BULLETIN

NUMBER 125

SUBJECT: Fuel System Model PA-23

MODEL AFFECTED: Model PA-23, Serial Numbers listed below

SKETCH "A"

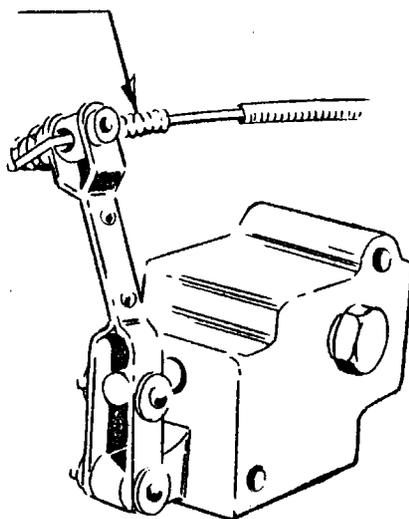
Therefore, to positively eliminate this condition, it is necessary to immediately inspect the attachment of the flexible wire to the fuel valve handle to determine if the set screw and lock nut are tight and to rework the end of the flexible wire in accordance with the Sketch "A" shown on the reverse side of this Bulletin. The Models affected are Serial Numbers 23-1 to 23-32 inclusive and 23-37.

SOLDER SEVERAL
TURNS OF SAFETY WIRE
TO CONTROL CABLE TO
PREVENT SLIPPAGE
